Docket Number: NG23-015
Subject Matter: First Data Request
Request to: NorthWestern Energy (NorthWestern or Company)
Request from: South Dakota Public Utilities Commission Staff
Date of Request: September 8, 2023
Responses Due: September 14, 2023

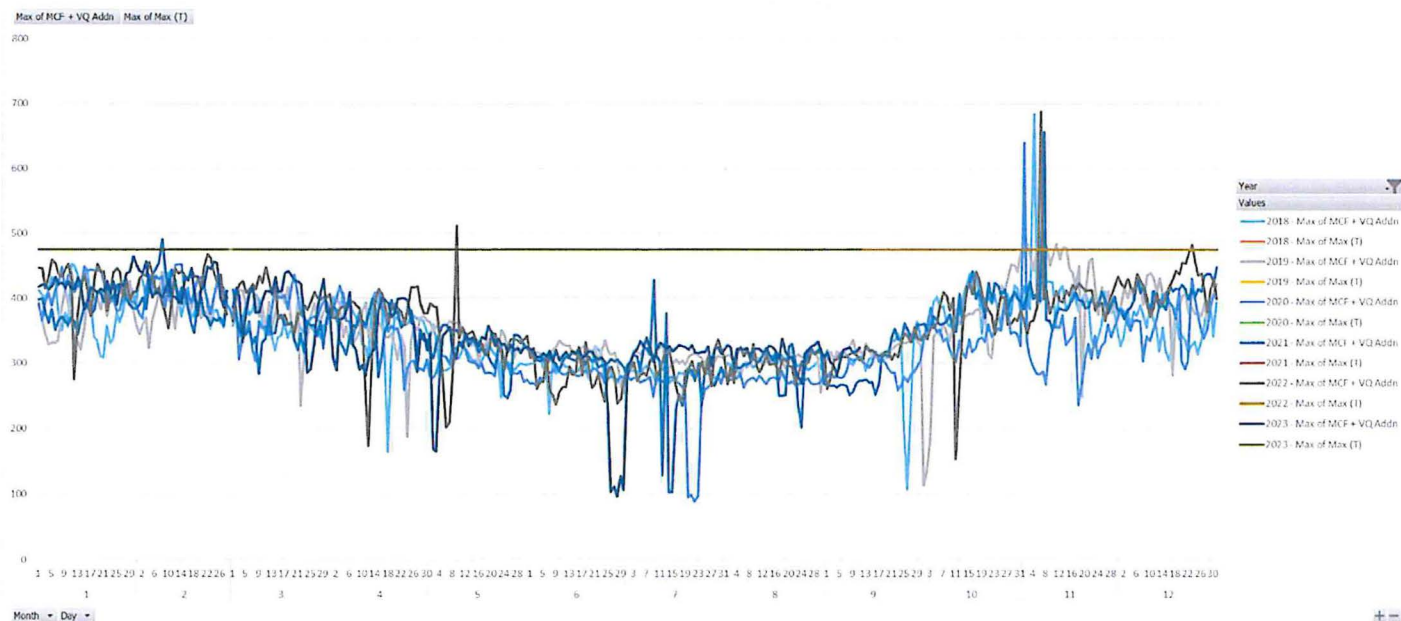
1-2. How often does NorthWestern anticipate Valley Queen will be interrupted?

Based on data collected since 2018, NWE estimates that 9% of the time, there is a risk to Valley Queen (VQ) of partial or total curtailment based on conditions on the transmission system feeding Milbank. The chart below shows the at-risk period. This period is any point where the new load from VQ, plus the historic use at any given time is greater than the known historical flow amount at the tap. Above this amount, ability to transmit gas to Milbank will be determined by multiple other loads on the line, which may or may not result in VQ being curtailed. It is important to note that this improvement project is to mitigate shortfalls in the capability of the Milbank distribution system to transport gas from the TBS to the VQ plant. These shortfalls need to be addressed for VQ to grow, whether their growth is firm or interruptible. This project does not address the transmission system, which is expected to be the driver of curtailment.

**note: this chart represents the maximum hourly flow/day. Because of the large quantity of data points, showing every hour on this chart is not feasible. There may be multiple at risk hours in each day.*
